# 21-61SP & 21-62SE – Ranch Road Staff Report

<b>Address:</b>	2600 Rustic Road & 1700 Ranch Road
<b>Requests:</b>	SP: Development of 303 multifamily units and amenity center SE: Relief from Sec. 122-434(1)(b) to reduce the required number of parking spaces to 1.6 spaces per unit
<b>Owner:</b>	AG EHC (MTH) Multi State 1, LLC
<b>Applicant:</b>	South City Partners
<b>Agent:</b>	Bill Conerly, P.E. – Kimley-Horn and Associates
<b>Parcel ID:</b>	0362001007, 0362001015, & 0362001002
<b>Parcel Size:</b>	15.85 ± acres
<b>Future Land Use:</b>	Mixed Use Residential (MUR)
<b>Zoning:</b>	Planned Unit Development (PUD)
<b>Comprehensive Plan Neighborhood:</b>	Knights Trail
<b>Application Date:</b>	December 27, 2021
<b>Associated Petition:</b>	21-63CU

### Site Plan Overview

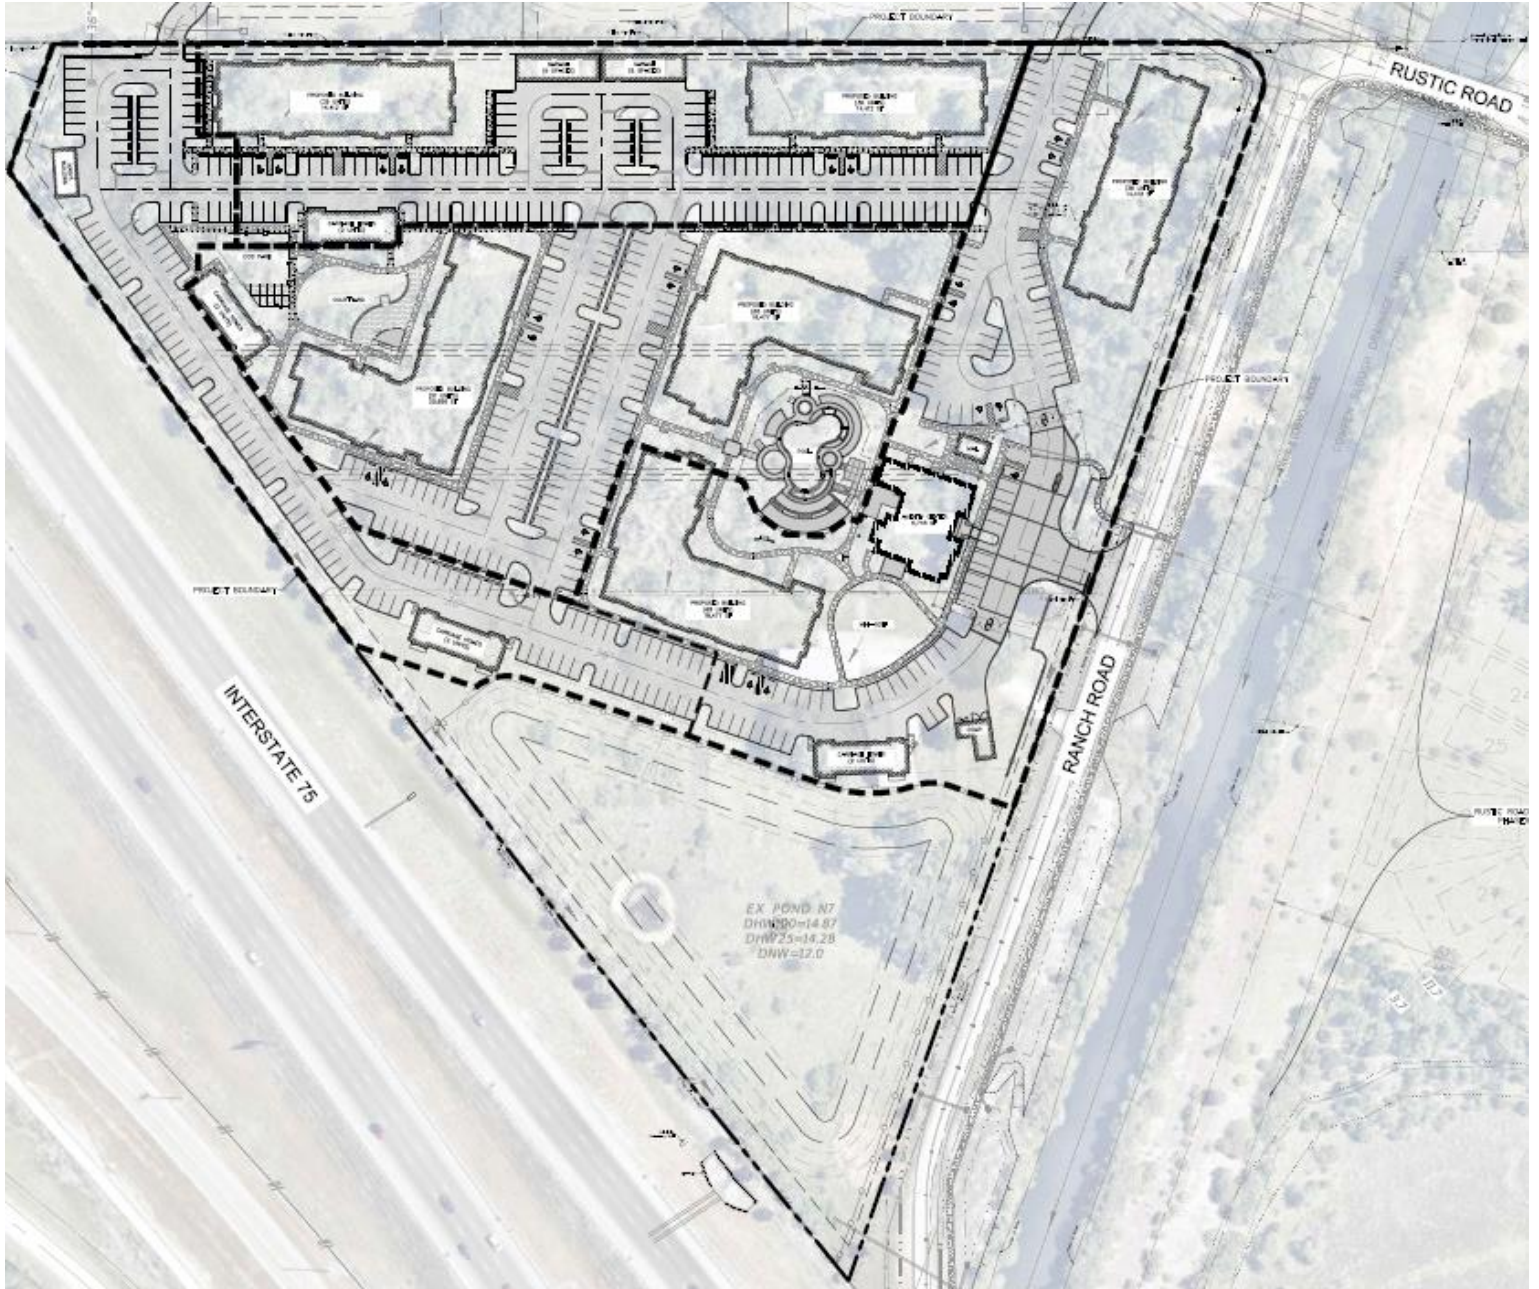
The proposed site plan has been reviewed for compliance with the Land Development Code and has been deemed compliant. The parking rate requested through the special exception and the height requested through the conditional use are the only items that do not meet the requirements of the Land Development Code and Binding Master Plan without additional approval.

Development Standard	PUD Requirement	Subject Petition Proposal
Lot Coverage	Unrestricted	17.22%
Setbacks	Front: 20' Side: 5' Rear: 10' Setback from I-75: 1x building height	Front: 46' Side: 17' Rear: 27' Setback from I-75: 43' (for building with height of 27.5')
Parking	606 spaces (Sec. 122-134)	485 spaces

*Staff Comment: Access is provided to the site at one main entrance along Ranch Road and two access points to the north, one from Rustic Road and one connecting to Magnolia Bay north. Sidewalks and crosswalks are provided throughout the site for pedestrian safety.*

*Staff Comment: Parking is provided both as surface parking and as garage parking.*

*Staff Comment: Screening and buffering is proposed compliant with the Land Development Code and consistent with the Binding Master Plan, including increased buffering along the PUD perimeter adjacent to I-75.*
